APPLICATION NO.	FILING DATE	FIRST NAMED INVENTOR	ATTORNEY DOCKET NO.	CONFIRMATION NO.
10/621,904	07/17/2003	Larry G. Willemsen	KSR-11302/08	2130
25006	7590	09/20/2005	EXAMINER	
GIFFORD, KRASS, GROH, SPRINKLE & CITKOWSKI, P.C PO BOX 7021 TROY, MI 48007-7021			LUONG, VINH	
			ART UNIT	PAPER NUMBER
			3682	
DATE MAILED: 09/20/2005

Office Action Summary

ATTACHMENT

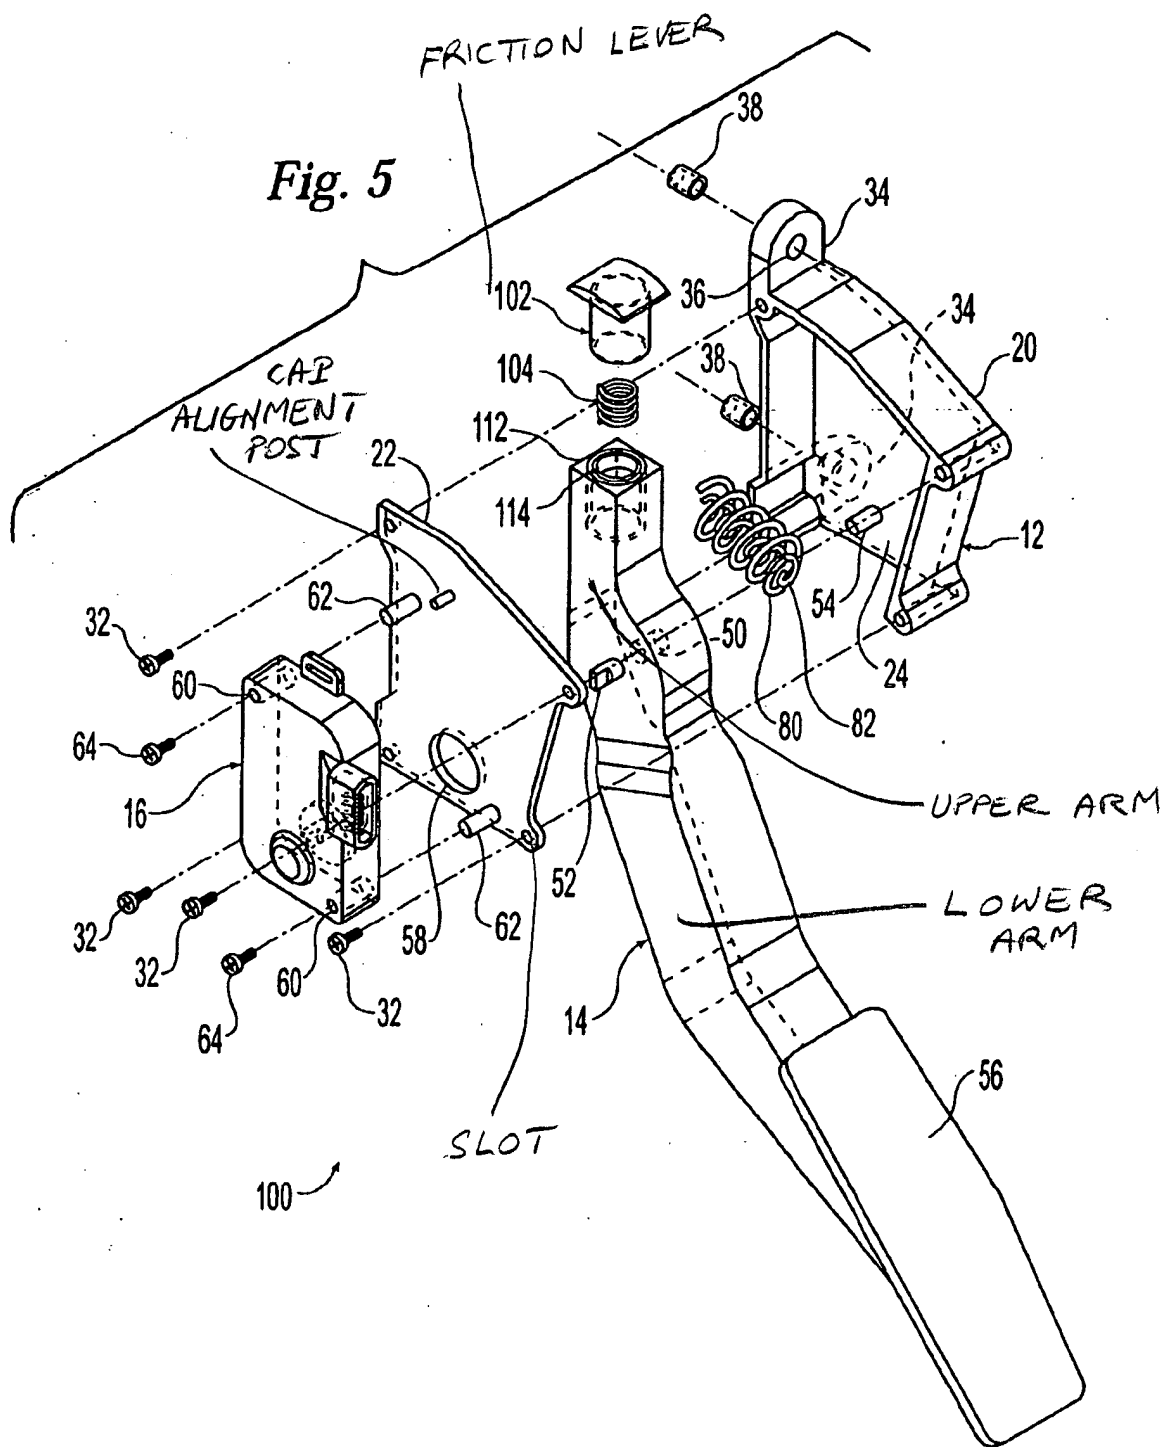
a pedal arm 14 having an upper arm (see Attachment) and a lower arm (Att.) and is rotatably supported at said pedal arm pivot point 52 that is between said upper pedal arm (Att.) and said lower pedal arm (Att.) by a mounting means 52 operatively connected to said housing 20;

Regarding claim 7, said pedal arm 14 includes a disk portion (Att.), and said lower pedal arm (Att.) extends from a lower edge (Att.) of said disk portion (Att.) and said upper pedal arm (Att.) extends from an upper edge (Att.) of said disk portion (Att.).

an alignment post (unnumbered in Fig. 5. See Att.) extending radially from a face portion of said cap 22, wherein said alignment post (Att.) aligns said cap 22 with said pedal arm pivot point 52;

Fig. 6

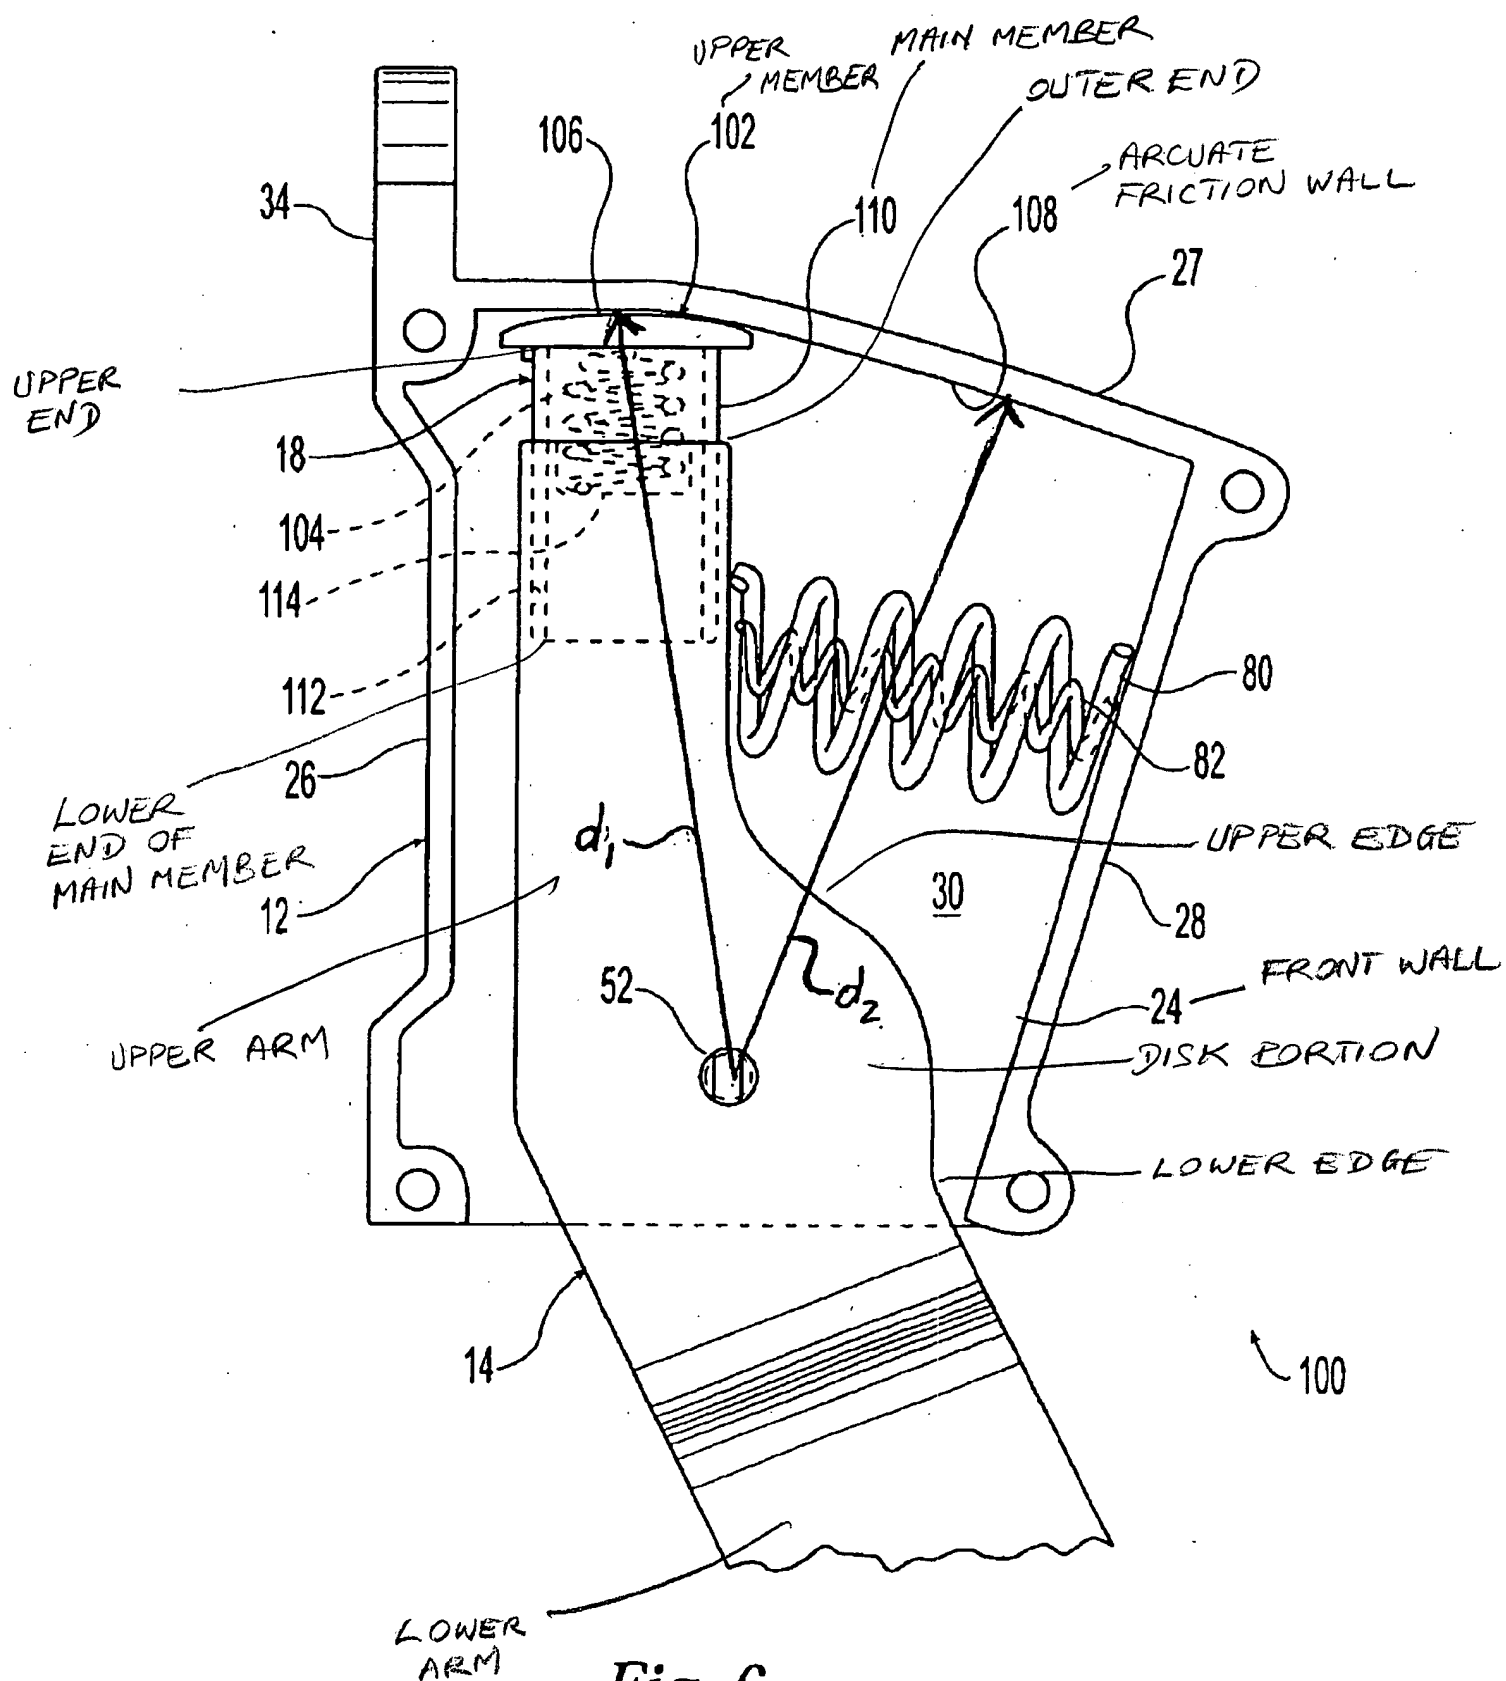
a housing 20 having a front wall 24 (Figs. 5-7) and an arcuate friction wall 108 extending from an edge of said front wall 24 wherein said friction wall 108 has a radius of curvature d_1 or d_2 centered on a pedal arm pivot point 52 (Fig. 6);

a hysteresis generating means 18 (*id.*, col. 8, line 1 *et seq.*) pivotally mounted to said upper pedal arm (by a cavity 112 wherein the hysteresis is pivoted about the pivot 52 as seen in Fig. 6. *Ibid.*, col, 8, lines 19-49); and

a pedal arm 14 rotatably supported at said pedal arm pivot point 52 by a mounting means 52 operatively connected to said housing 20, wherein said pedal arm 14 includes a disk portion (Fig. 6, Att.), a lower pedal arm (Att.) extending from a lower edge (Att.) of said disk portion (Att.) and an upper arm (Att.) extending from an upper edge (Att.) of said disk portion (Att.) and said pedal arm pivot point 52 is between said upper pedal arm (Att.) and said lower pedal arm (Att.);

a hysteresis generating means 18 pivotally mounted to said upper pedal arm (by the cavity 112 so as to pivot about the pivot axis 52 as seen in Fig. 6. See Att.), wherein said hysteresis generating means 18 is a friction lever 102 pivotally mounted (by the cavity 112) to an outer end (Fig. 6. See Att.) of said upper pedal arm (Att.) at a friction lever pivot point 52; and
